Reply on RC2

R2: The manuscript presents the most recent version of the WaterGAP model (v2.2e). Refinements, new algorithms, and updated data for calibration are presented. The manuscript is well-written, and the overall evaluation section is comprehensive and competently performed. My primary concern is the link between the extensive software modifications and data increment and the overarching scientific goal of assessing global and regional water resources. Even though the modifications, data additions, and model evaluation are comprehensively described, their scientific significance is not sufficiently justified in the context of water resources assessment. In this sense, I consider revisions (mostly related to rephrasing and further discussions) to be needed before publication. Please see below for my specific comments:

Fig. 1: Schematics of the WaterGAP framework and the WaterGAP Global Hydrology Model (both taken from Müller Schmied et al., 2021) and summary of data updates, process updates and new algorithms.

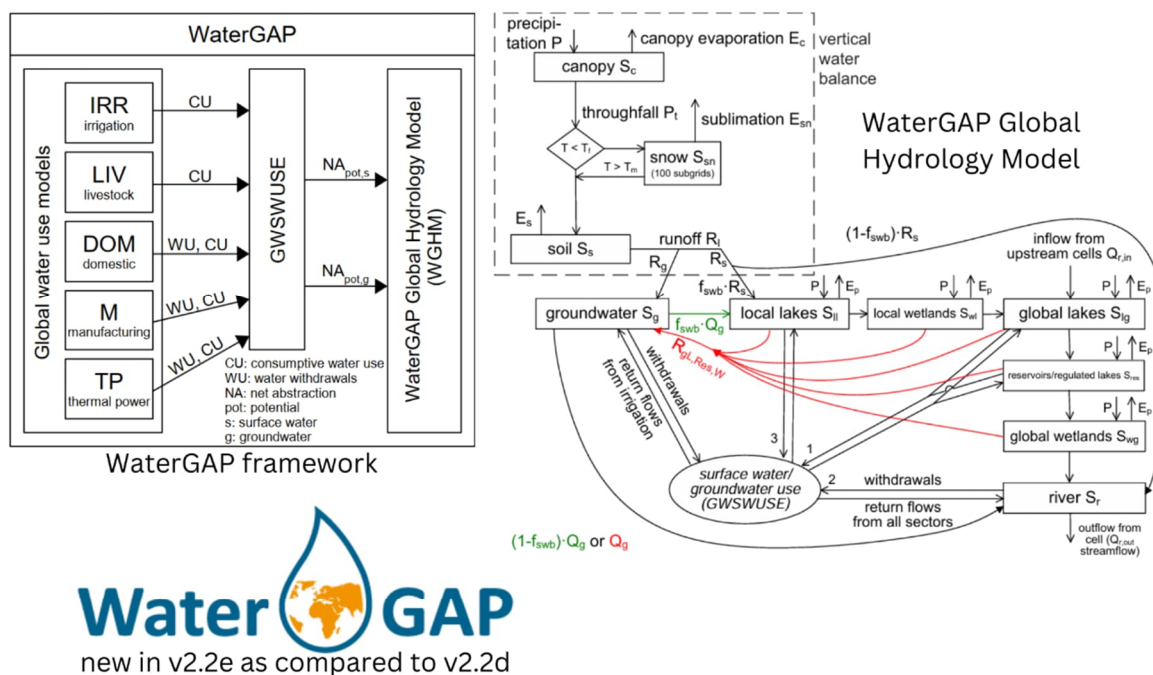
R2: Comment 2: The model modifications are widely discussed in Section 2. However, as a reader, it is hard to visualize the model as a whole and identify the modified components. A scheme presenting the model's overall structure with the modified stages highlighted might be helpful.

Answer: Thank you for this suggestion. We agree that showing the schemes is a good idea. However, the general structure has not changed as compared to the 2.2d paper, so we re-use these two figures (side-by-side) and highlight the new features in model version 2.2e in a summarized form inside this figure. We believe this also helps the reader for introduction (see our reply to your Comment 1).

Action: We add a new Fig. 1 to the introduction and describe the general concept (see above).

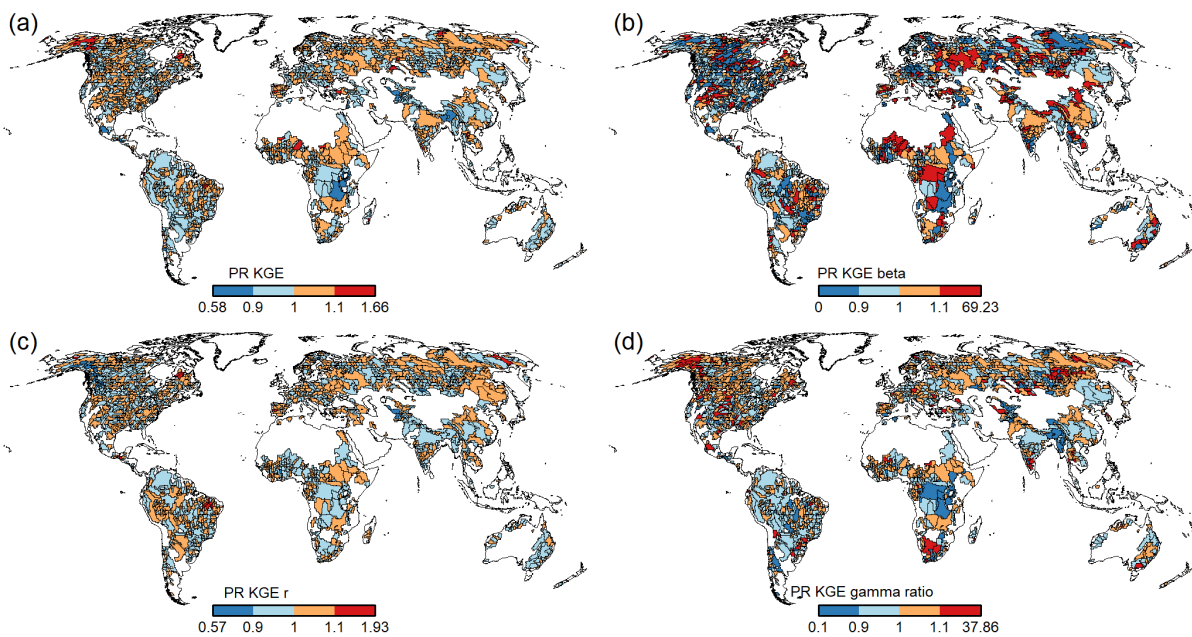
R2: Comment 4: Section 5 presents the effects of the model modifications on multiple areas and the impact of differential forcing. Overall, the effect of the implemented changes seems to be minor. However, I found it challenging to visualize the minor differences because most of the baseline results (from v2.2d) are presented in Supplementary Material. I would recommend summarizing the results as differences of v2.2e from the original implementation rather than presenting each version independently. Furthermore, this issue connects to my general comment about the lack of scientific justification for the model modifications. If model parametrizations and data changes lead to almost negligible changes, the scientific rationale for implementing them should be discussed further.

are not in the standard version. But we fully agree, it is hard to see differences especially from the global basin maps, and a direct comparison might help here.

Action: We created spatial maps that show differences of model performance on a basin level, for 2.2e vs. 2.2d. The motivation is to see, where the difference to the optimal value (in terms of model performance indicator) is reduced or increased between the two versions that are driven by the same climate forcing and calibration data. For all indicators we calculate this difference as the ratio of the absolute deviation from the optimal indicator value (here everywhere 1.0) as:

Figs 2 and 3 will be included in Section 7.5.1 (WaterGAP 2.2e vs. WaterGAP 2.2d) with a brief description, the indicator description PR_[IND] added as Appendix C
